## ORIGINATION FORM

### Proposed Revisions to a Standard Plans Index (Please provide all information — Incomplete forms will be returned)

Index Number: 455-154

Index Title: 60" Prestressed CFRP & SS Concrete Cylinder  
Pile**Summary of the changes:**

INDEX  
455-160

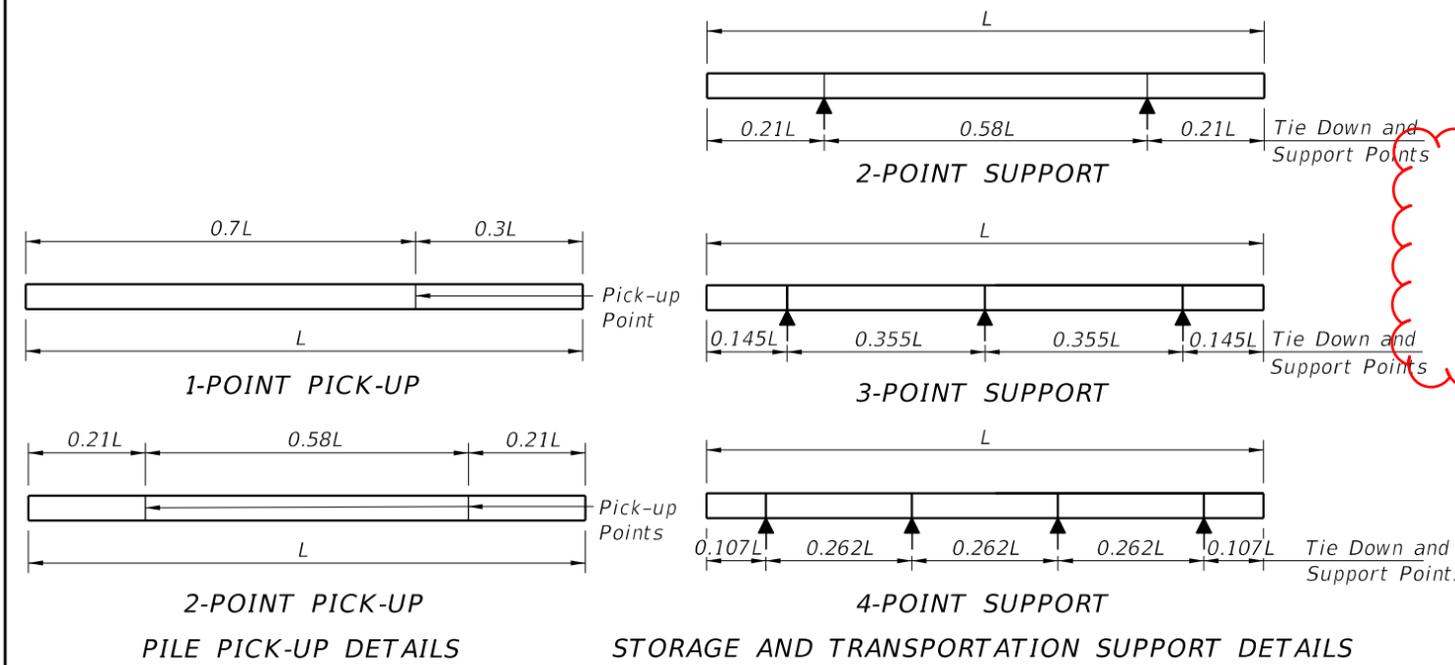
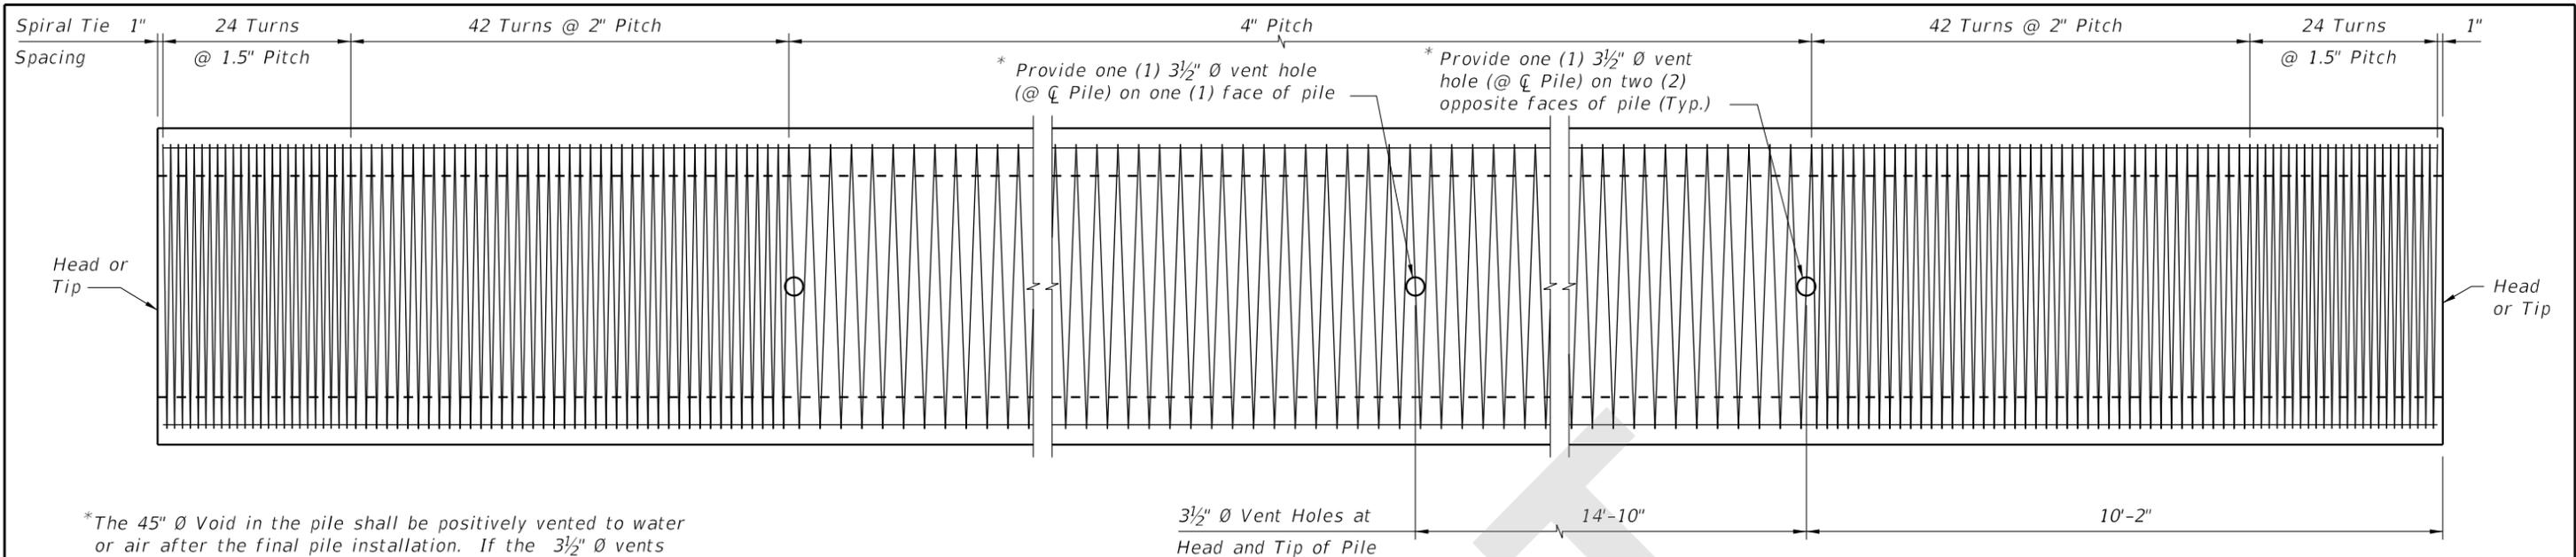
- Work this Index with the Pile Data Table in the Structures Plans.
- Concrete:
  - Piles: Class V (Special)
  - Splice Collar: Class IV
  - ~~Silica Fume: See "GENERAL NOTES" in the Structures Plans for locations where the use of silica fume, metakaolin or ultra-fine flyash is required.~~

Highly Reactive Pozzolans

Change Silica Fume, metakaolin or ultra-fine flyash to Highly Reactive Pozzolans

Specification changed to fit silica fume, metakaolin and ultra-fine flyash under Highly Reactive Pozzolans

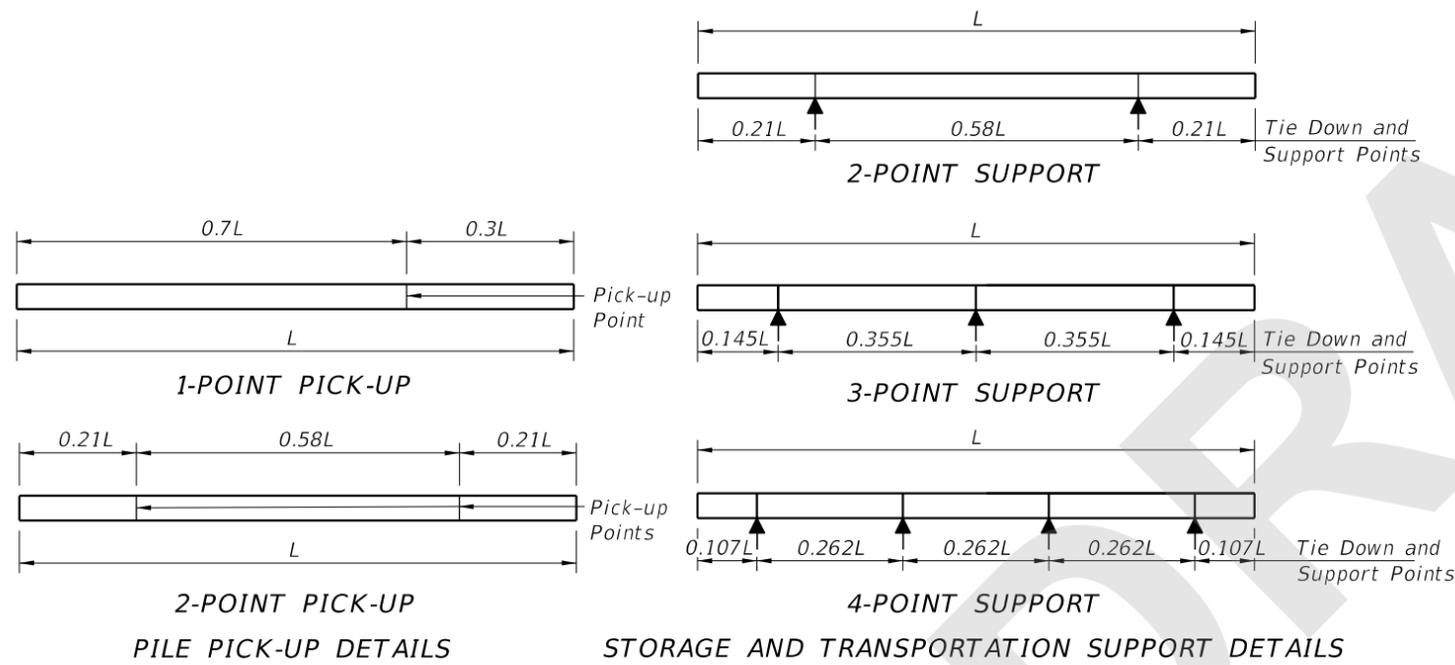
1. Work this Index with the Pile Data Table in the Structures Plans.
2. Concrete:
  - A. Piles: Class V (Special)
  - B. Splice Collar: Class IV
  - C. See "GENERAL NOTES" in the Structures Plans for locations where the use of Highly Reactive Pozzolans is required.
